MEMORANDUM

TO: District of Columbia Board of Zoning Adjustment
FROM: Stephen Gyor, Case Manager
 Joel Lawson, Associate Director Development Review
DATE: November 6, 2012

SUBJECT: BZA Case 18443, 3616 14th Street NW, request for variance relief under to allow the conversion of a two-story retail/office building to a three-story retail/residential structure.

Figure 1: Front of Subject Property

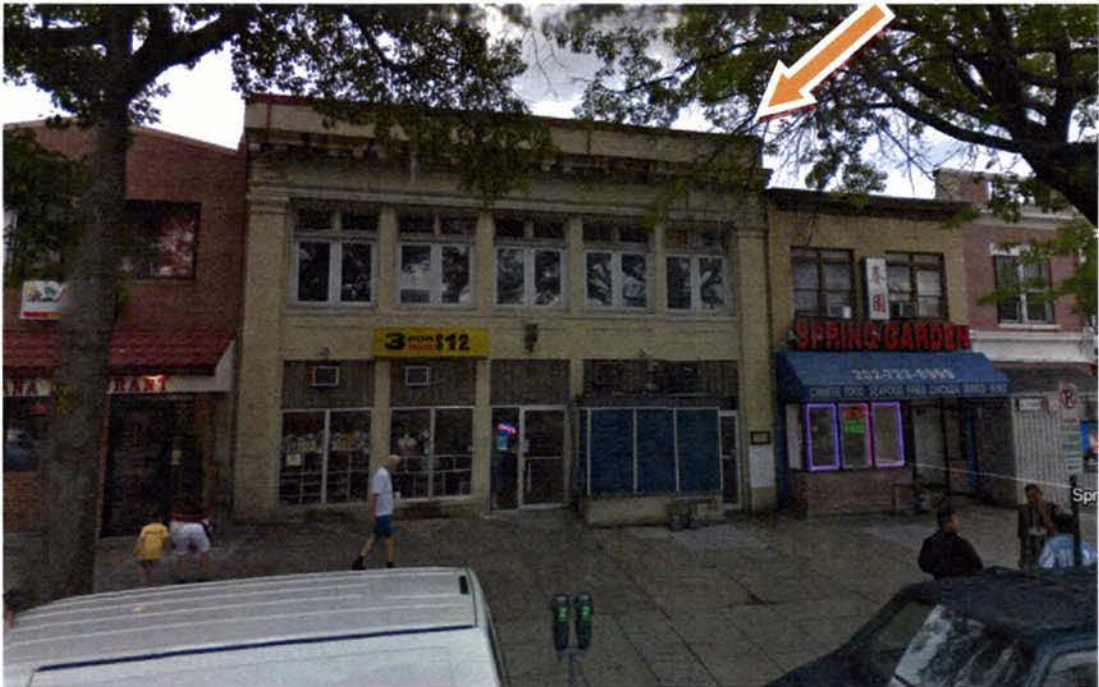
Although the subject structure was built in 1920 and is not located in a historic district, it nevertheless contributes to the character of the surrounding neighborhood. In OP's view, the proposed design of the third floor addition could be improved. As

noted above, the third floor should be set back from the front façade or designed to be consistent with the lower two floors. For example, the third floor windows should align with the windows on the lower floor, and the material proposed by the applicant, metal cladding, seems to conflict with the existing facade treatment on the first and second floors.
